STANDARD DEPARTURE CHART - INSTRUMENT

RJNH / HAMAMATSU

TACAN Y RWY27

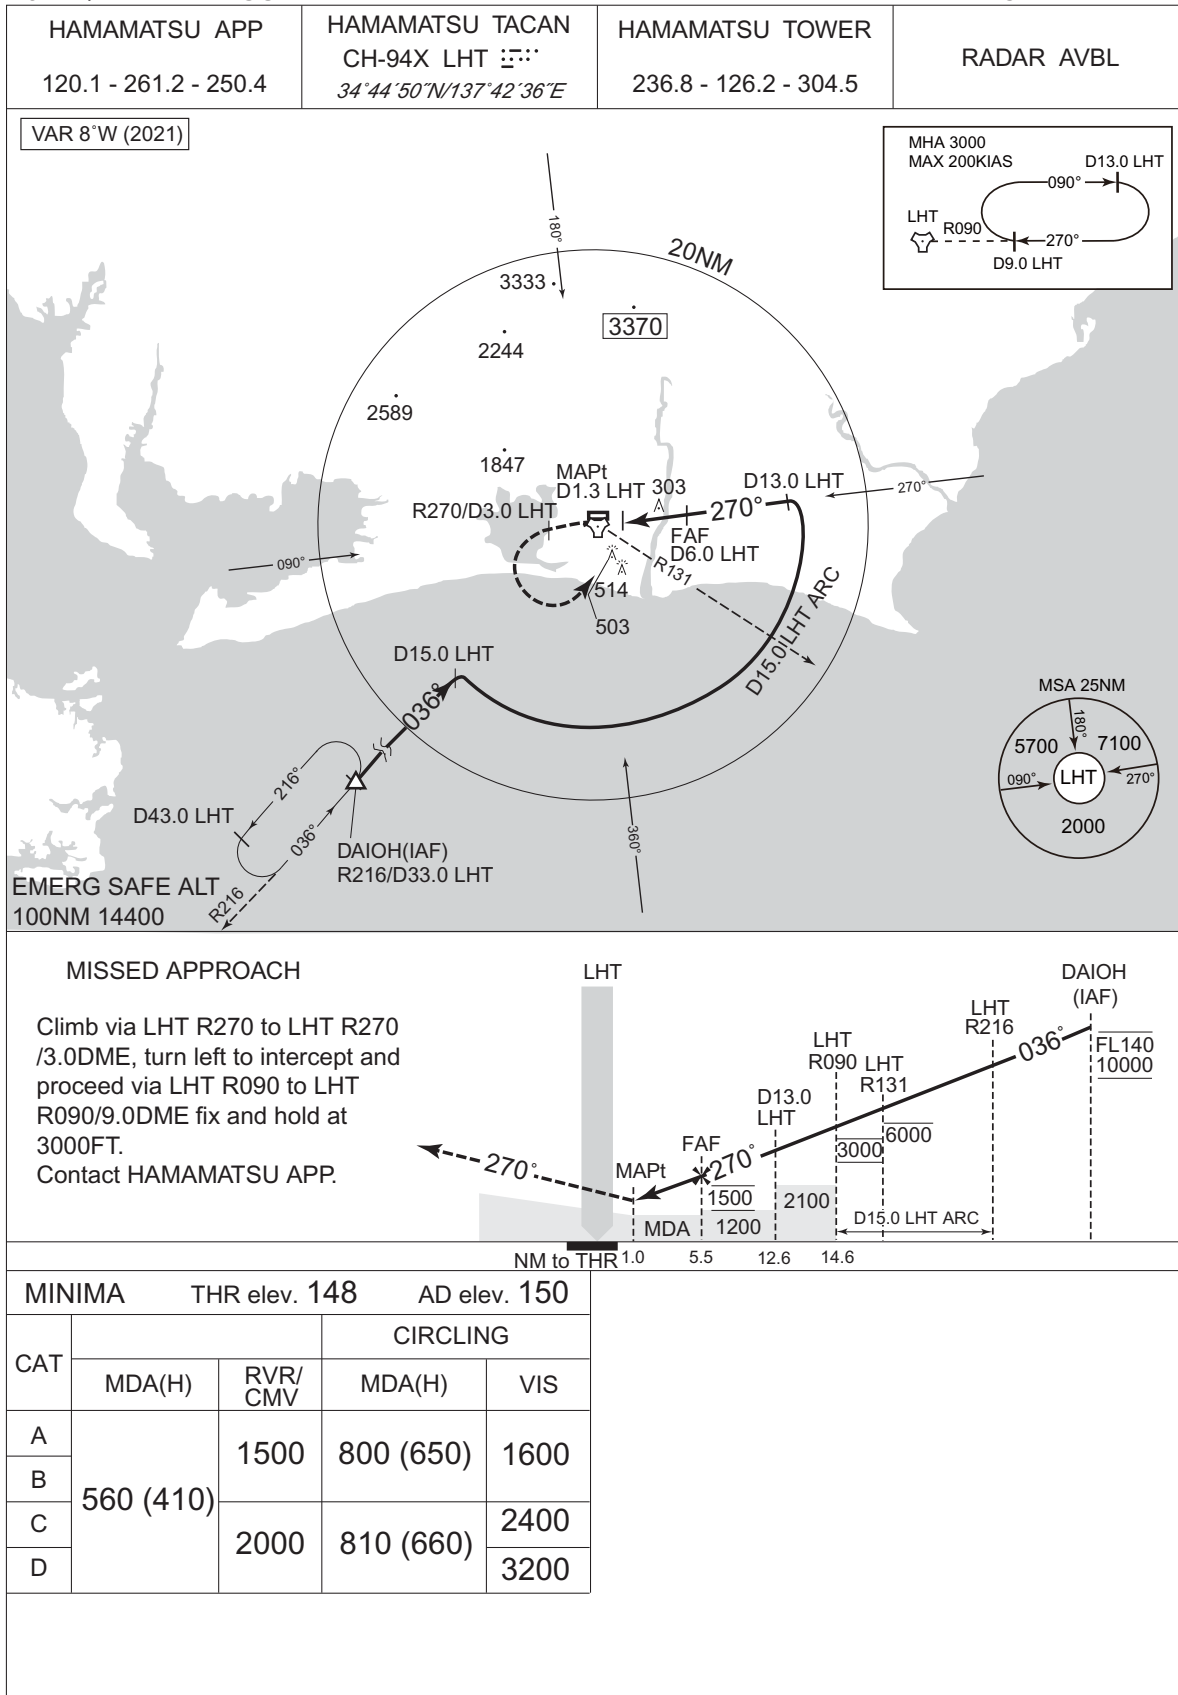
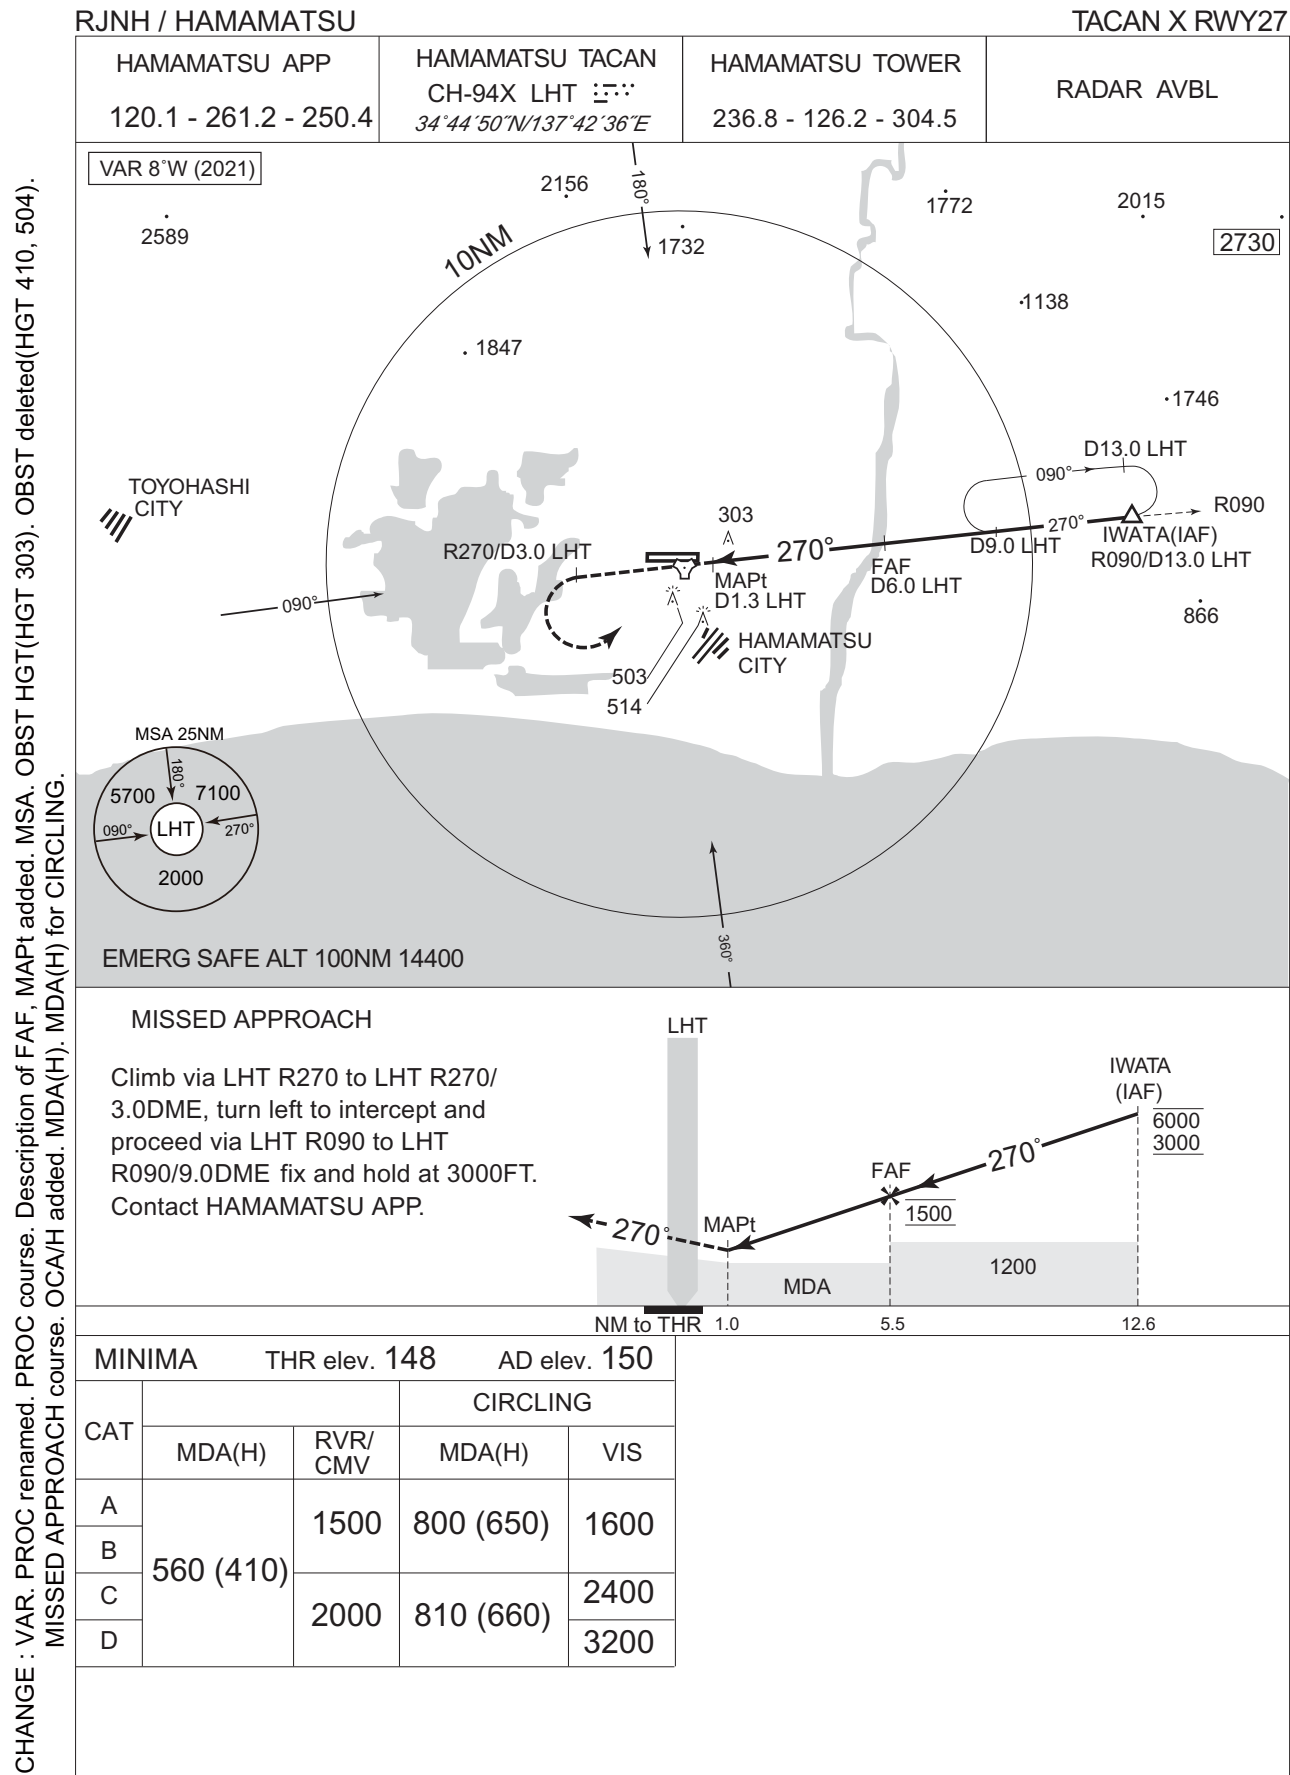
CHANGE : VAR. PROC renamed. PROC course. Description of FAF, MAPt added. MSA. OBST HGT(HGT 303). OBST deleted(HGT 410, 504). MISSED APPROACH course. OCA/H added. MDA(H). MDA(H) for CIRCLING.
